## APPLICATION FOR CERTIFICATE OF APPROPRIATENESS HISTORIC CONSERVATION BOARD PUBLIC HEARING STAFF REPORT

APPLICATION #: COA20190878  
APPLICANT: Jeckering Schneider Architects  
OWNER: Chris Slater and Elizabeth Dale  
ADDRESS: **1905 Baymiller Street**  
PARCELS: 184-0003-0068, and -0069  
ZONING: Residential Multi-Family (RM 1.2)  
OVERLAYS: Dayton Street Historic District  
COMMUNITY: West End  
REPORT DATE: November 25, 2019,  
STAFF REVIEW: Beth Johnson, Urban Conservator

The applicant is requesting a Certificate of Appropriateness for a one story garage addition to 1905 Baymiller Street and a rear 3<sup>rd</sup> floor addition and deck.

**Site Plan** 3  
Scale: 1"=20'-0"

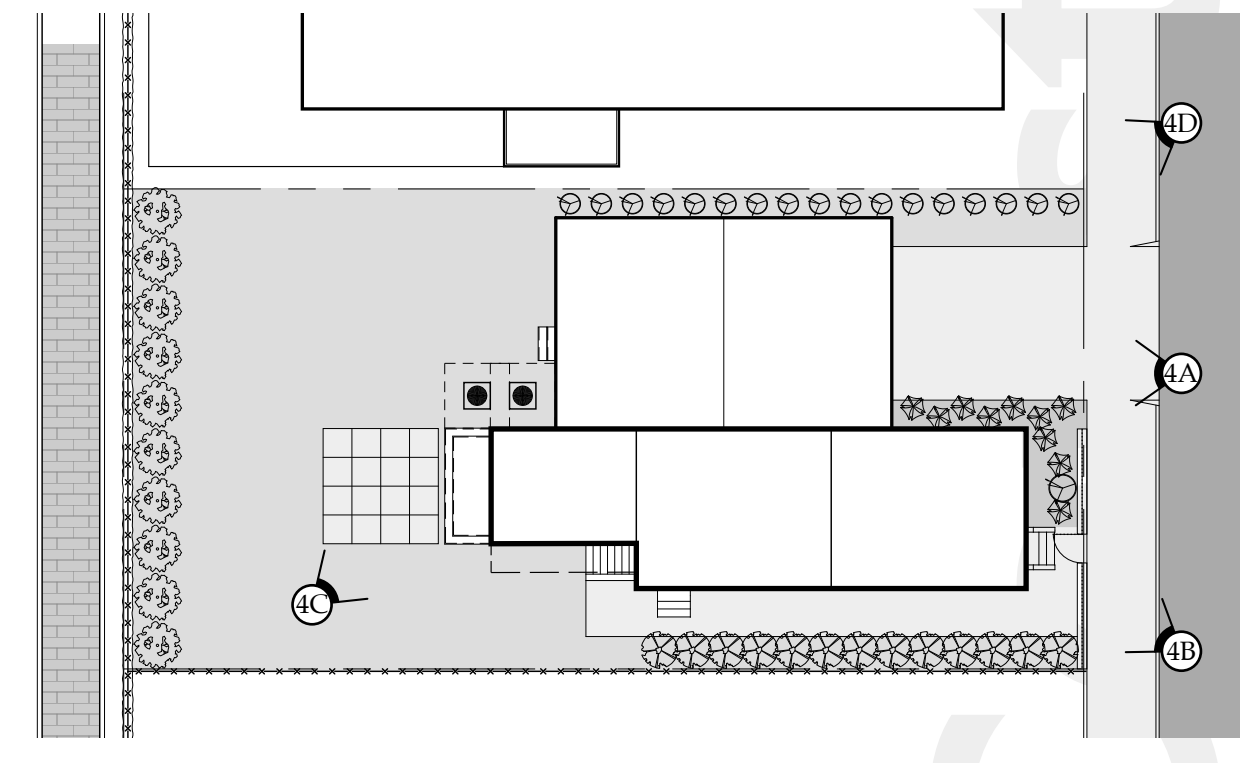
*The applicant desires a garage at this property. The use of the alley is impractical due to significant grade changes between the elevation of the alley and the rear yard. Orienting the vehicle access to the rear would require demolition of the historic wall. There is an existing curb cut on the front of the property. As this block has a lot of variation of setback and height, the massing of this project is considered compatible within the block.*

**03a**

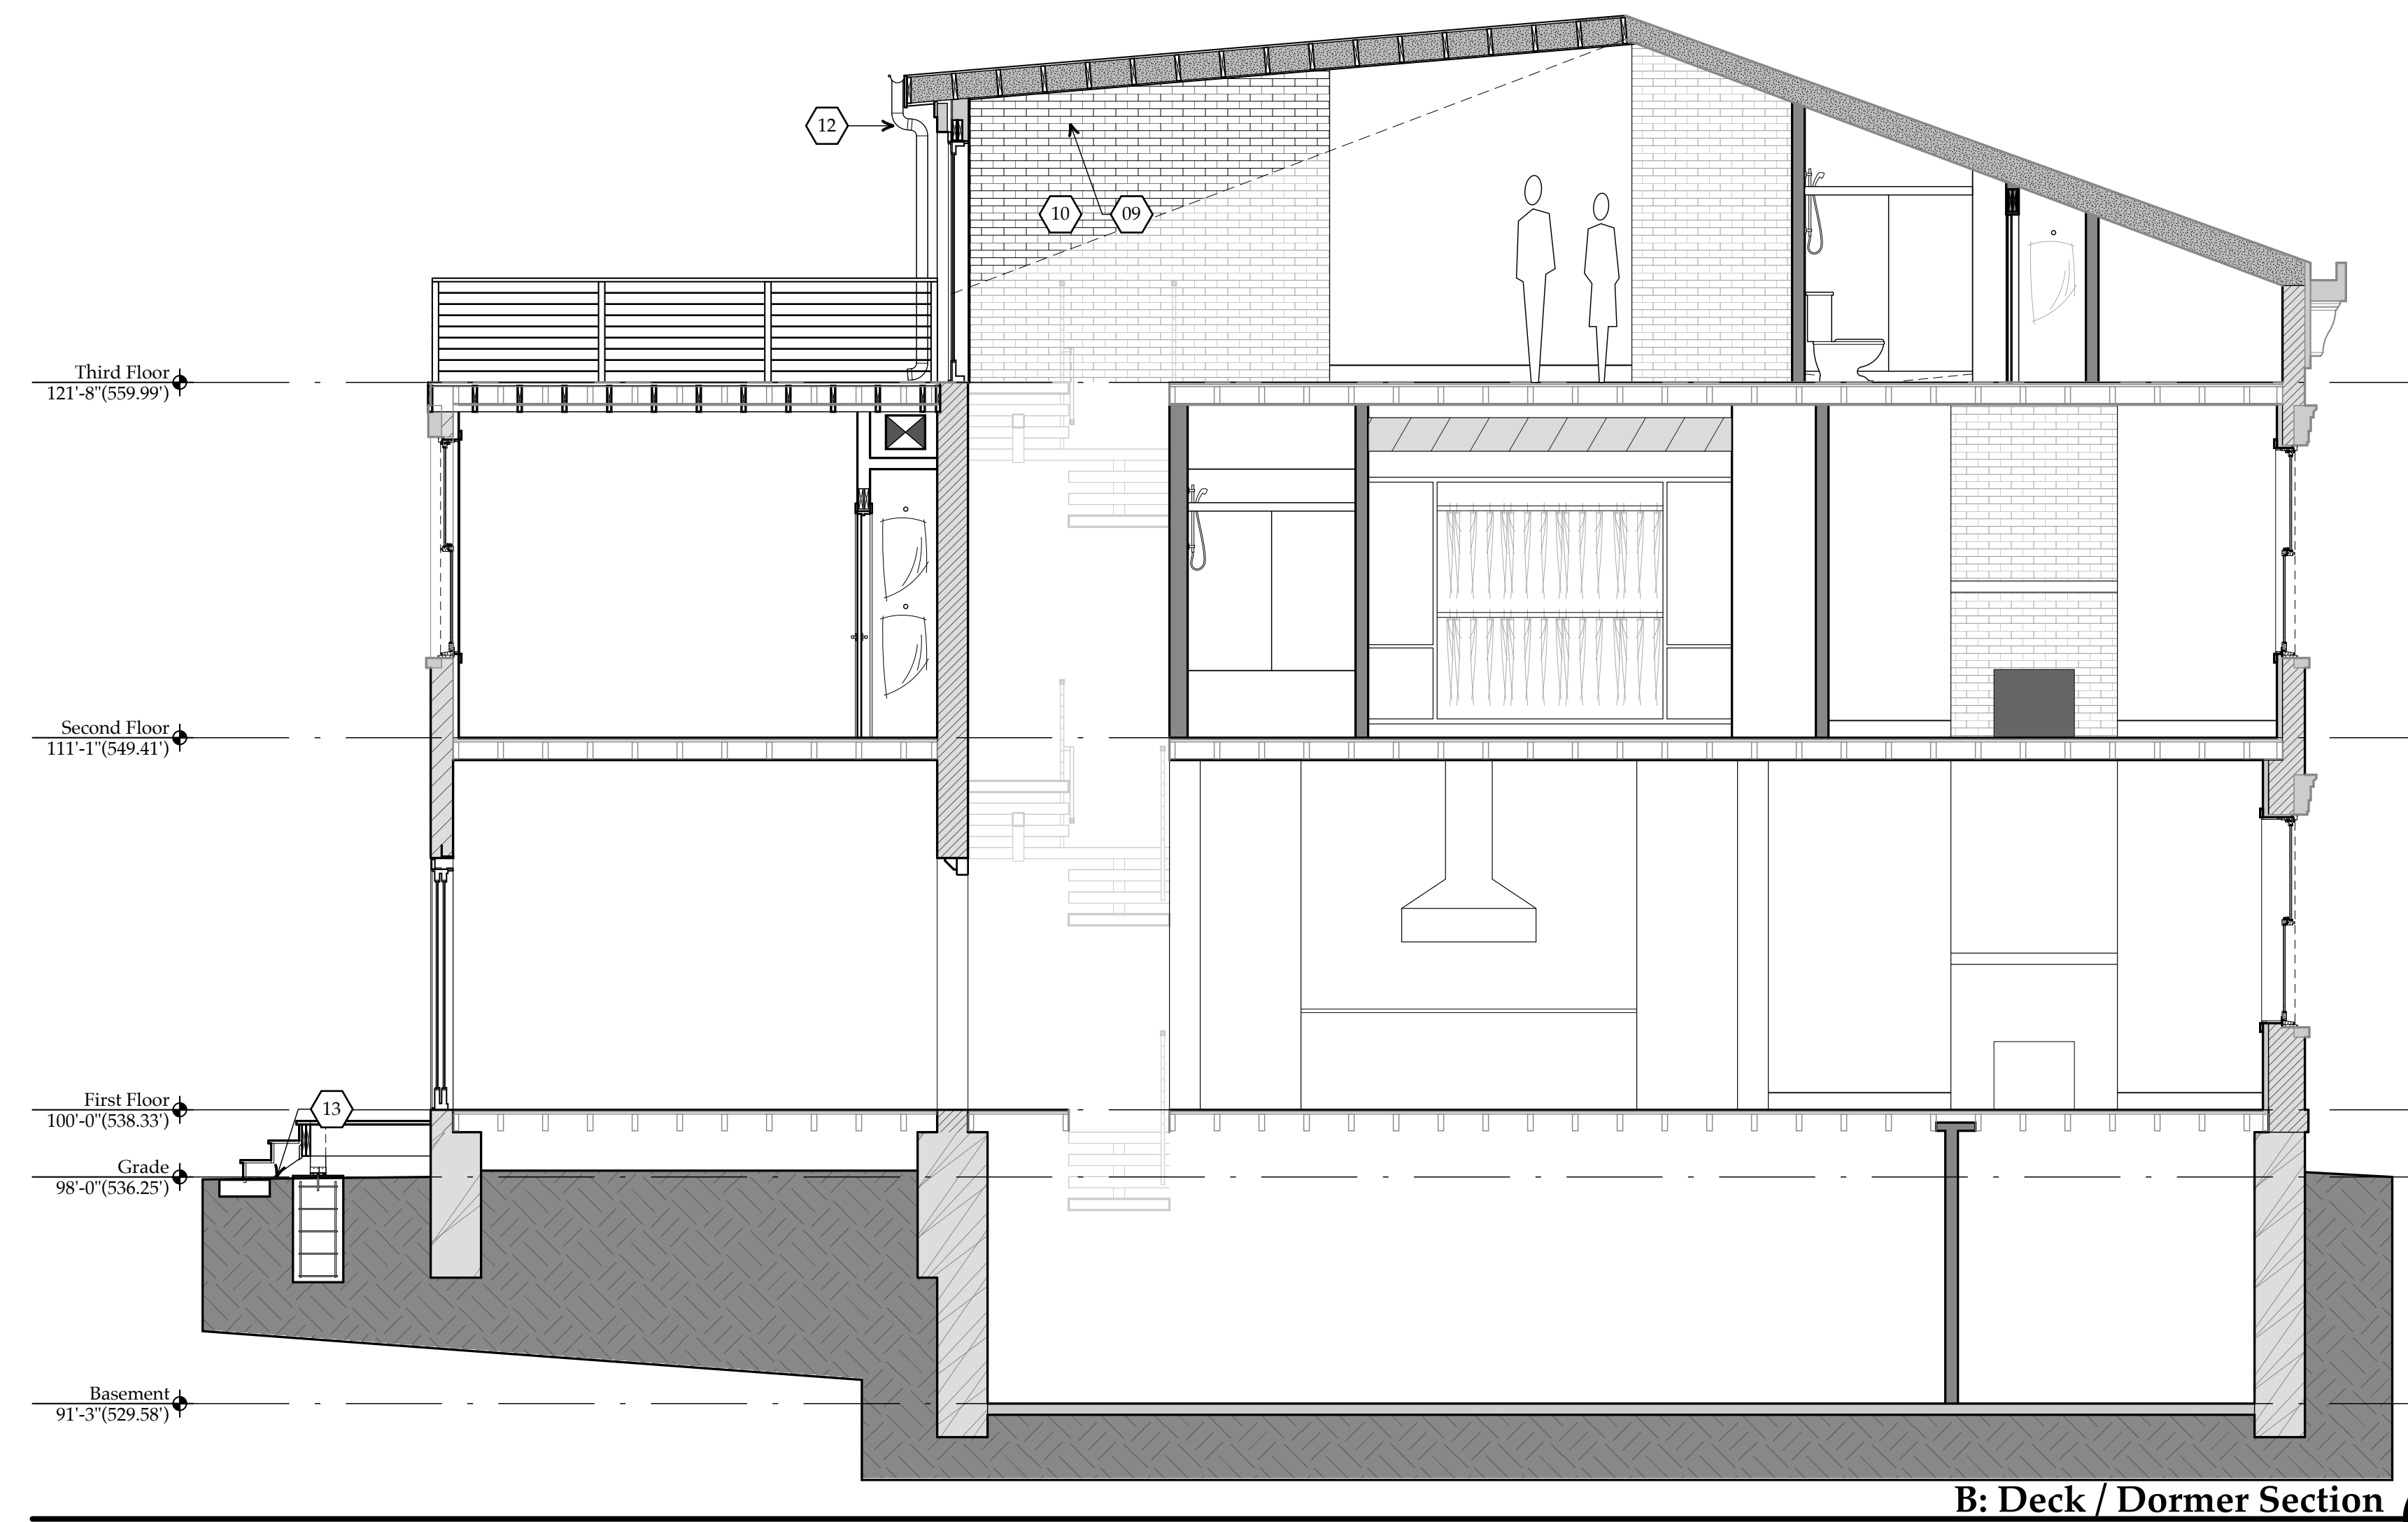
*The main opening on the addition is a garage door. The proposed garage doors are an appropriate style. The applicant has designed brick detailing on the north to mimic openings to provide relief to a large expanse of brick side that will be visible from the street.*

*The original roof shape at the front will be retained and the rear will be raised to allow for more livable space within the house. While this will be visible from the street it will not overwhelm the building or change the architectural contributing nature of the building. The street presence of the building will remain. This is another example of balancing the programmatic needs with the guidelines.*
